**ADDENDUM No. 2: January 13, 2016**  
**Reissued 2-29-16 No Changes**

**PROJECT:** St. John the Baptist Parish  
Edgard Library Addition/Renovation  
Edgard, Louisiana 70049

**PROJECT NO.:** SA 21205.00

ESK-E201.1

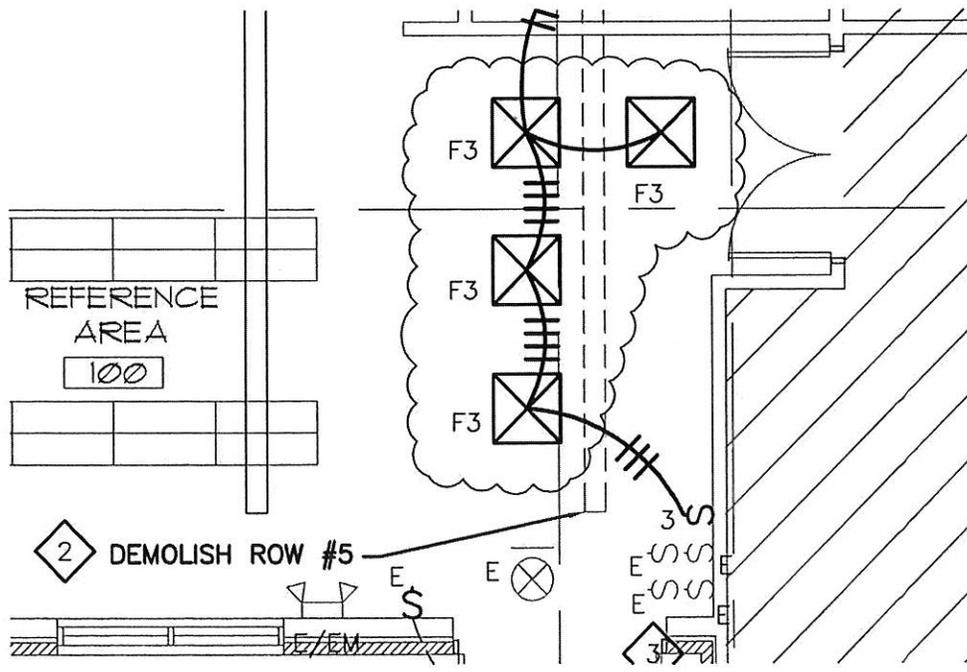
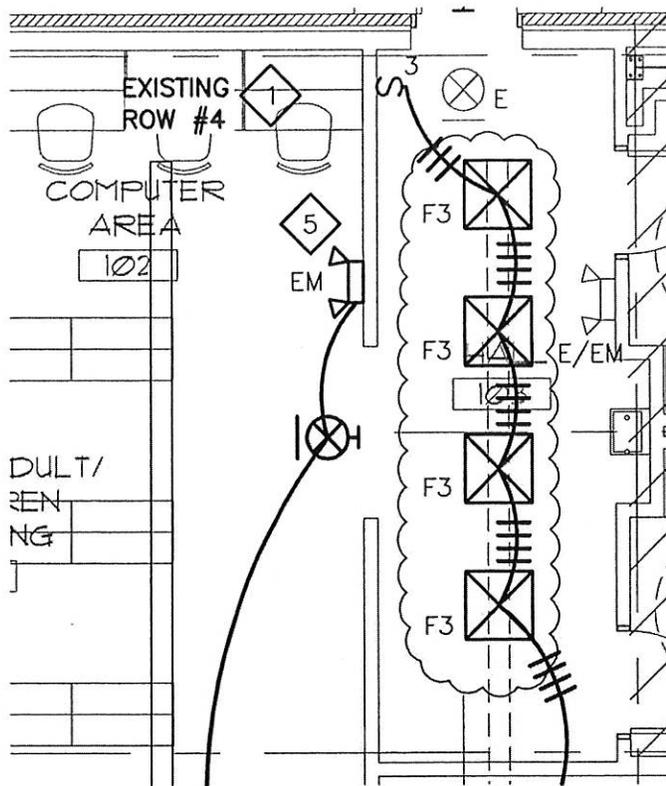
1. Sheet E100; Revise the F3 light fixture to the following:  
2'x2', 2-lamp, recessed linear fluorescent, volumetric, 17W T8, 3000K, 80 CRI; Equals: Metalux 2 AC, Simkar AHPD, Day-Brite 2AT
2. Sheet E100; Revise the F3A light fixture to the following:  
2'x2', 2-lamp, recessed linear fluorescent, volumetric, flanged trim kit for hard ceiling, 17W T8, 3000K, 80 CRI; Equals: Metalux 2AC, Simkar AHPD, Day-Brite 2AT
3. Sheet E201; Add F3 light fixtures and associated circuitry. See attached Sketch ESK-E201.1. (ATTACHMENT #1)
4. Sheet G102; Add to the NOT IN CONTRACT LIST the following: *"4. The Owner will be responsible for trimming the existing oak tree branches near the front*
